Project	IEEE 802.16 Broadband Wireless Access Working Group <a href="http://ieee802.org/16">http://ieee802.org/16</a> >	
Title	Bandwidth Request for Non-Transparent RS	
Date Submitted	2006-11-07	
Source(s)	Yuefeng Zhou Mike Hart Sunil Vadgama Fujitsu Laboratories of Europe Ltd Hayes Park Central, Hayes End Road,	Voice: +44 (0) 20 8573 4444 FAX: +44 (0) 20 8606 4539  yuefeng.zhou@uk.fujitsu.com mike.hart@uk.fujitsu.com sunil.vadgama@uk.fujitsu.com
	Hayes, Middlesex, UB4 8FE, UK	
Re:	IEEE 802.16j-06/027: "Call for Technical Proposals regarding IEEE Project P802.16j"	
Abstract	This contribution provides some text to clarify how a non-transparent RS with distributed scheduling function requests bandwidth for the R-UL and how the MR-BS handles the reception of MAC PDUs transmitted within the allocated BW.	
Purpose	Discuss and adopt proposed text and message format.	
Notice	This document has been prepared to assist IEEE 802.16. It is offered as a basis for discussion and is not binding on the contributing individual(s) or organization(s). The material in this document is subject to change in form and content after further study. The contributor(s) reserve(s) the right to add, amend or wi

Figure 25—A new MAC PDU replaces all grouped MAC PDUs

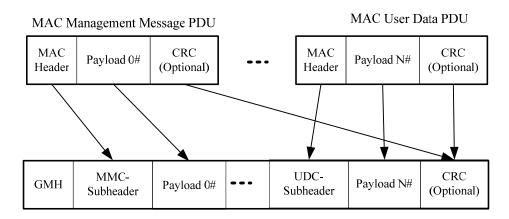
[Insert a new subclause 6.3.2.2.1]

6.3.2.2.1 MAC PDU Combination for MR

RS may combine the received access-link MAC PDUs into a single MAC PDU for R-UL transmission to save MAC/PHY overhead. Figure 26 illustrates this concept for R-UL MAC PDU combination. The combined MAC PDU can be uplink MAC Management messages or user date. A new CID for combined MAC PDU will be applied to this combined MAC PDU. Management Message Combination subheader (MMC-subheader in 6.3.2.2.7), and User Data Combination subheader (UDC-subheader in 6.3.2.2.8) will be used to describe each combined MAC management message and user data respectively. Before combining the MAC PDUs, RS may categorize the received MAC PDUs based on the QoS demands, and then the MAC PDUs within same category may be combined.
